STATE OF NORTH CAROLINA  
DEPARTMENT OF TRANSPORTATION

**Subject: Request for Modification and Permit Renewal for Section 404 General Permit No. 198200031 and Section 401 Water Quality Certification** for the Interstate 485 (I-485) improvements from I-77 to US 74 (Independence Boulevard), Mecklenburg County, Division 10, TIP I-5507.

**Reference:** 1) Section 404 Regional General Permit No. 198200031 (GP 31), Action ID No. SAW-2013-02330, issued December 18, 2019; 2) Section 401 General Water Quality Certification No. 4135, NCDWR Project No. 20191337v.1, issued December 2, 2019.

PERMIT DRAWING  
SHEET 11 OF 115

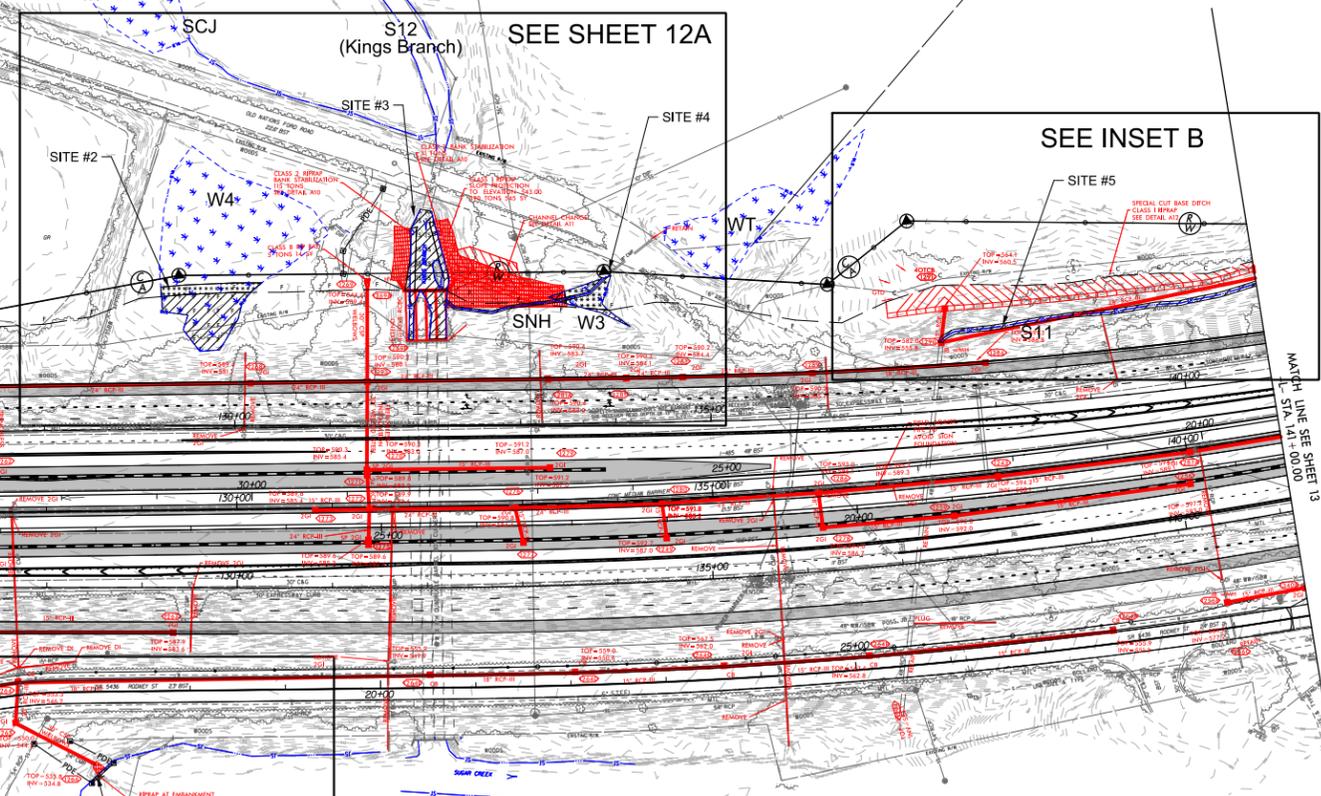
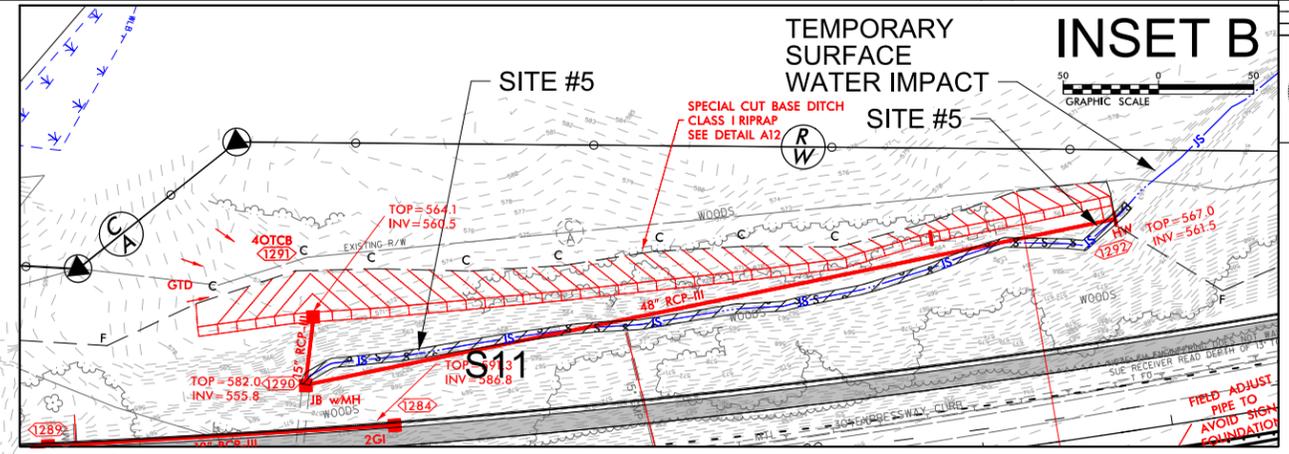
The original permitted design at Site 4 included 0.03 acre of permanent fill impacts to wetland W3 and 181 linear feet of permanent stream channel impacts to stream SNH due to roadway fill. In the revised design, the roadway fill slopes have been adjusted and a channel change is being proposed to stream SNH to avoid potential impacts to the sanitary sewer that have may have occurred when installing the previously proposed drainage. The revised design results in 95 linear feet of permanent stream channel impacts due to roadway fill, 35 linear feet of permanent stream channel impacts due to channel change, and 10 linear feet of temporary stream impacts. The revised design results in <0.01 acre of permanent wetland fill impacts due

to roadway fill, <0.01 acre of permanent wetland fill impacts due to the channel change, and 0.02 acre of mechanized clearing in wetlands. The revised design at Site 4 results in a reduction in permanent stream channel impacts of 51 linear feet and an increase in temporary stream impacts of 10 linear feet. Overall total permanent wetland impacts to wetland W3 will remain 0.03 acre, however permanent wetland fill impacts have been reduced by 0.02 acre and mechanized clearing in wetlands has been increased by 0.02 acre.

The original permitted design at Site 5 included 473 linear of permanent stream impacts and 10 linear feet of temporary stream impacts to stream S11. The previously authorized permanent impact included 54 linear feet resulting from a 48" reinforced concrete pipe (RCP) extension and 419 linear feet resulting from a channel change. The revised design includes 444 linear feet of permanent stream impacts and 10 linear feet of temporary stream impacts resulting from a 48" RCP extension with a junction box. The design change at Site 5 results in a reduction of 29 linear feet of permanent stream impacts and no change in temporary stream impacts. The design change is being made to eliminate the concern for possible future roadway slope stability issues, to reduce the amount of relocated channel needing regular maintenance and inspections on the project, and to reduce the possibility of a noise wall in the future by retaining the existing berm.

**SITE #3 AND SITE #5 NOTE:**  
THE EXISTING CULVERT IS NOT BURIED, THEREFORE THE CULVERT EXTENSION WILL NOT BE BURIED. THE BOTTOM ELEVATION OF THE EXTENDED CULVERT WILL MATCH THE ELEVATION OF THE EXISTING STREAM BED.

**SITE #3 AND SITE #5 NOTE:**  
THE EXISTING CULVERT IS NOT BURIED, THEREFORE THE CULVERT EXTENSION WILL NOT BE BURIED. THE BOTTOM ELEVATION OF THE EXTENDED CULVERT WILL MATCH THE ELEVATION OF THE EXISTING STREAM BED.

SHEET 112 OF 115

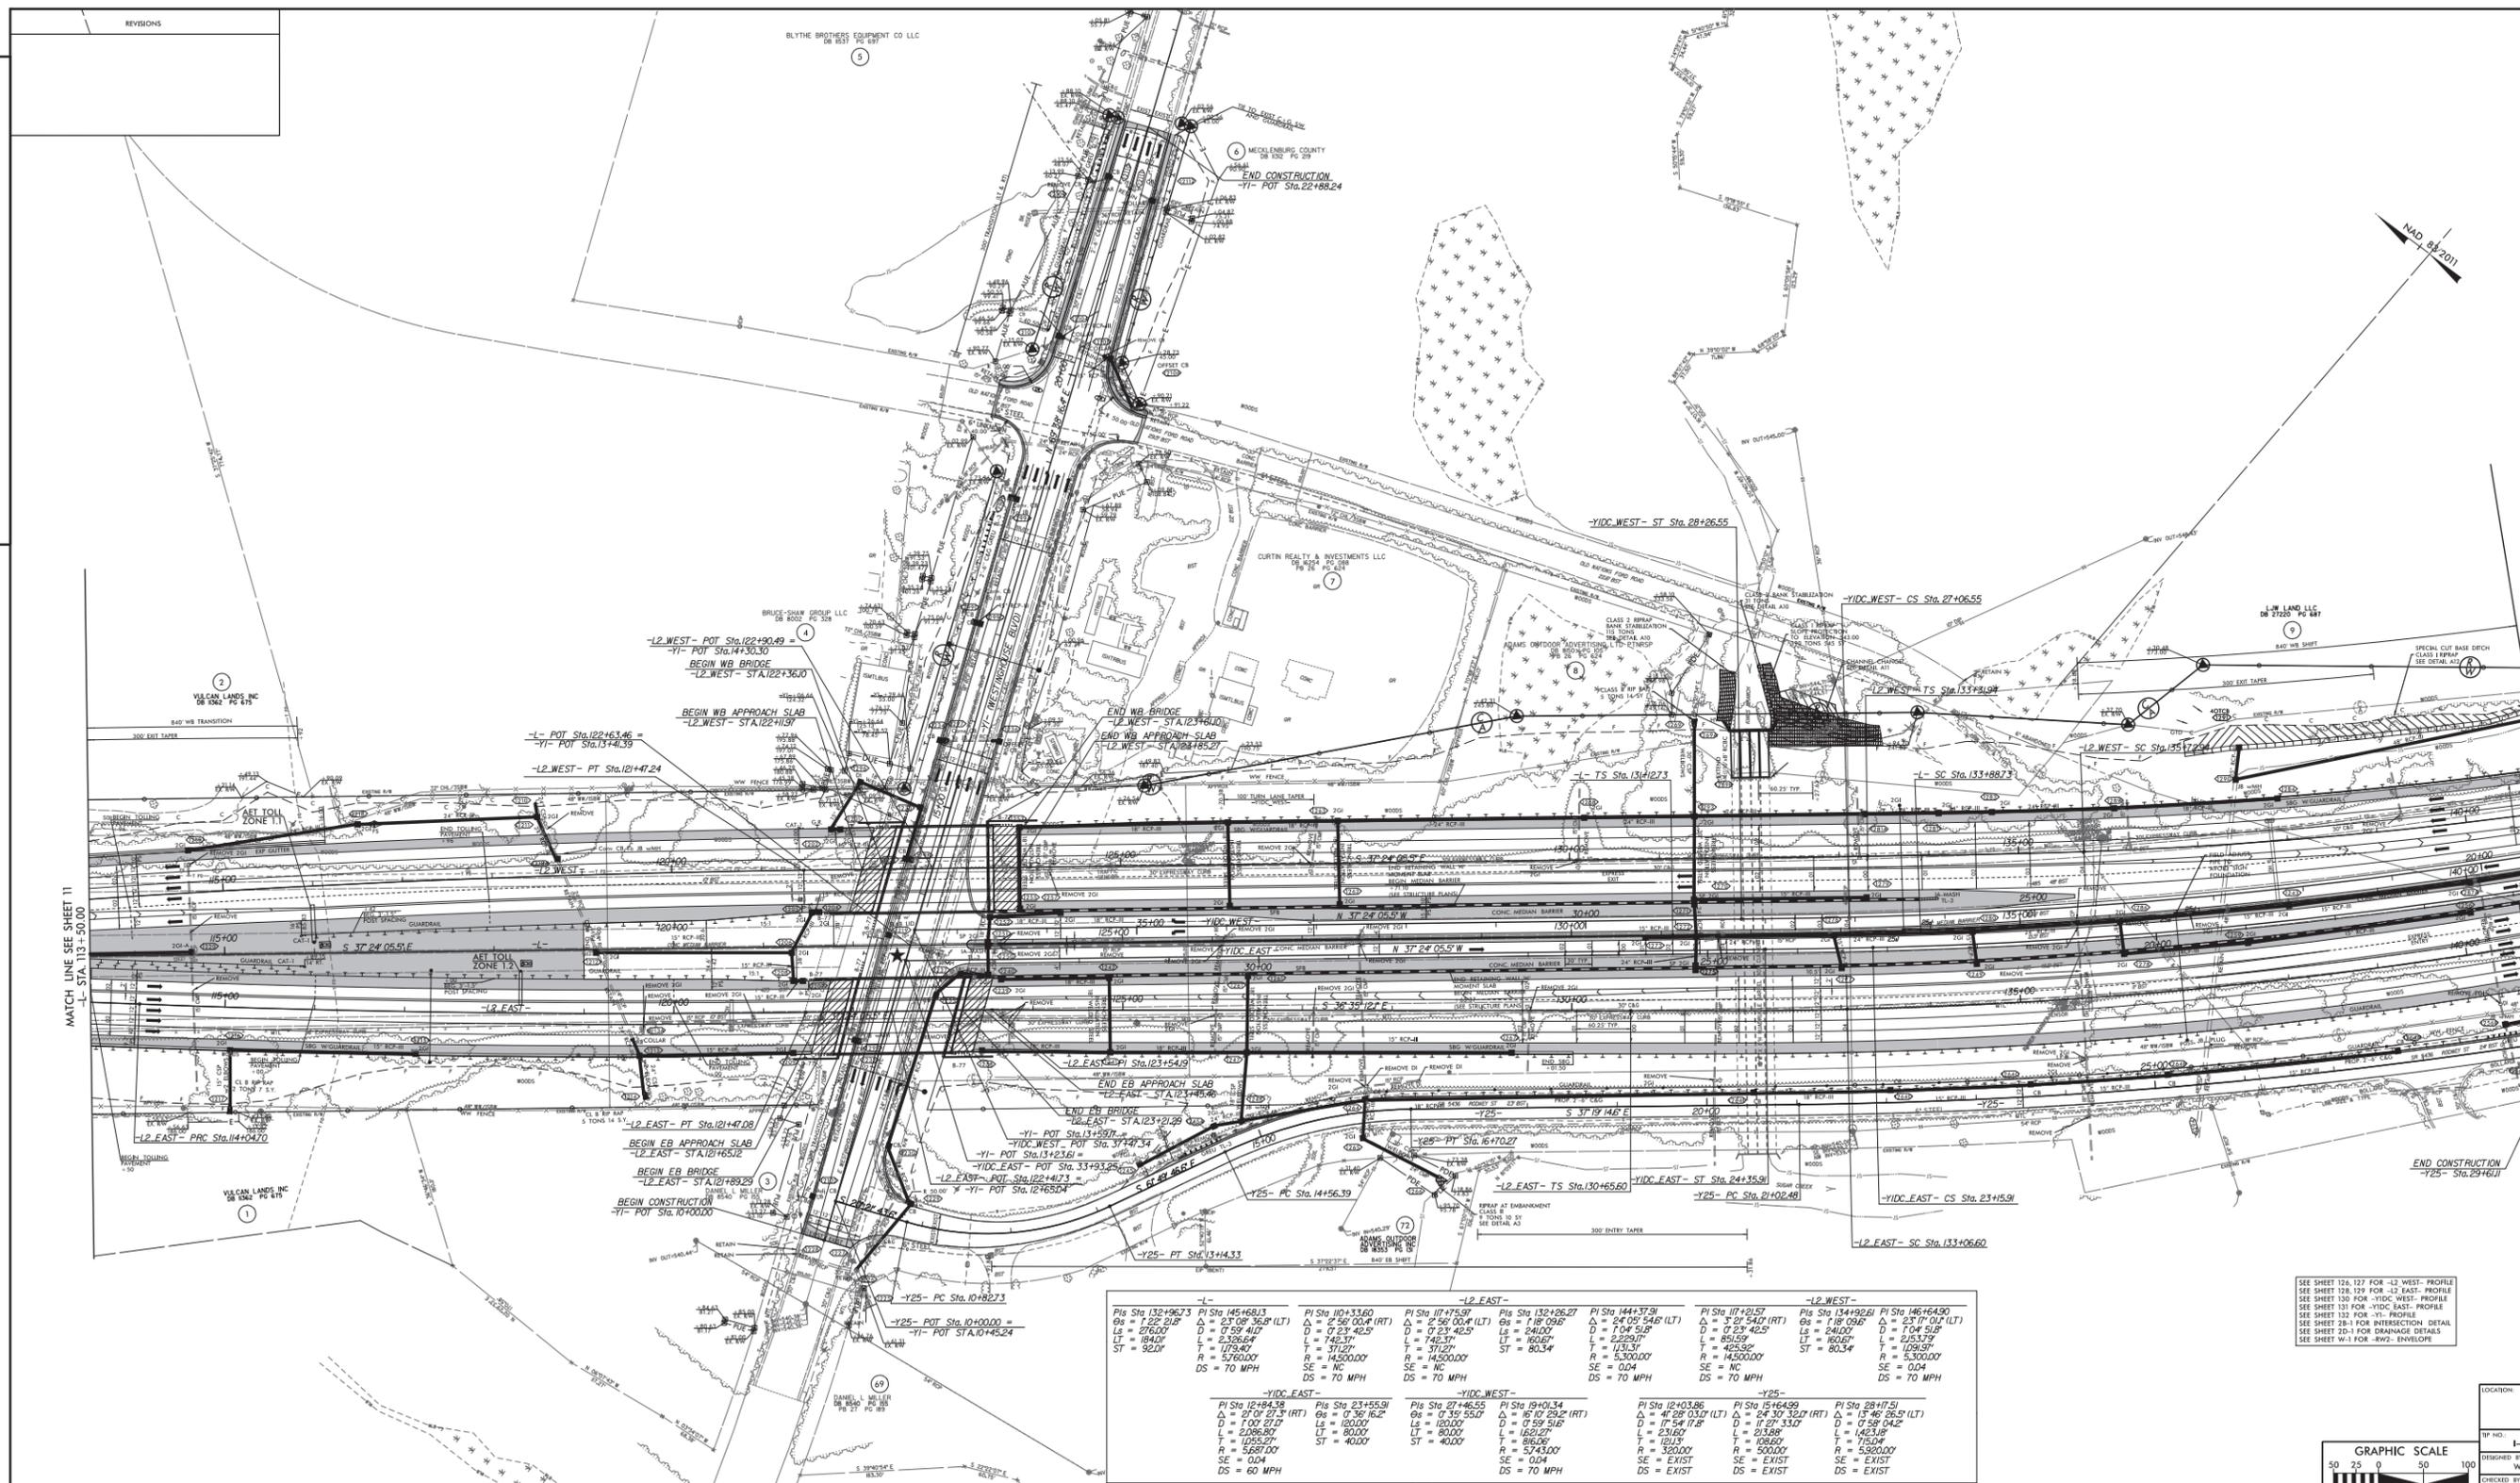
Site No.	Station (From/To)	Structure Size / Type	WETLAND IMPACTS					SURFACE WATER IMPACTS				
			Permanent Fill In Wetlands (ac)	Temp. Fill In Wetlands (ac)	Excavation in Wetlands (ac)	Mechanized Clearing in Wetlands (ac)	Hand Clearing in Wetlands (ac)	Permanent SW impacts (ac)	Temp. SW impacts (ac)	Existing Channel Impacts Permanent (ft)	Existing Channel Impacts Temp. (ft)	Natural Stream Design (ft)
1	110+50 -L- RT	Extend Existing 48" RCP						< 0.01		28		
1	110+50 -L- RT	Bank Stabilization						< 0.01	< 0.01	18	13	
2	129+00 - 130+00 -L- LT	Roadway Fill	0.08			0.02						
2A	128+50 -L- RT	Bank Stabilization						< 0.01	< 0.01	11	20	
3	132+00 -L- LT	Extend 4 @ 10'x8' RCBC						0.03		52		
3	132+00 LT	Bank Stabilization						0.02	< 0.01	70	16	
3	132+00 LT	Culvert Construction Activities							0.03			
4	132+00 - 134+00 -L- LT	Roadway Fill	< 0.01			0.02		< 0.01		95		
4	132+00 - 134+00 -L- LT	Channel Change	< 0.01					< 0.01	< 0.01	35	10

5	137+40 - 142+25 -L- LT	Extend 48" RCP with Junction Box						0.05	< 0.01	444	10	
6	293+50 -L-	Bank Stabilization						< 0.01	< 0.01	48	10	
7	294+00 - 301+00 -L- LT	Rock Plating							0.07		680	
8	298+00 -L- LT	Concrete Energy Dissipator						< 0.01		7		
8	298+00 -L- LT	Bank Stabilization						< 0.01		10		
9A	302+00 - 308+50 LT	Roadway Fill	0.05			0.05						
9B	309+50 -L- LT	Roadway Fill	0.07			0.07						
10	309+50 -L- LT	Bank Stabilization at Temp. Bridge						0.01	0.01	65		
11	343+00 -L-	Bank Stabilization at Temp. Bridge						0.03	0.05	157		
11	343+00 -L-	Drill Shaft Installation							0.05			
12	344+50 - 346+50 -L- RT	Roadway Fill	0.13			< 0.01						
13	360+00 -L- LT	Bank Stabilization						< 0.01	< 0.01	8	20	
13	360+00 -L- RT	Extend 3@ 9'x9' RCBC						0.01		49		
13	360+50 -L- RT	Bank Stabilization						< 0.01	< 0.01	38	20	
13	360+50 -L- RT	Culvert Construction Activities							< 0.01			
<b>TOTALS*:</b>			<b>0.33</b>			<b>0.17</b>		<b>0.18</b>	<b>0.25</b>	<b>1135</b>	<b>799</b>	<b>0</b>

- At Sites 1, 3, 5, and 13, the existing culvert is not buried, therefore the culvert extension will not be buried. The bottom elevation of the extended culvert will match the elevation of the existing stream bed.
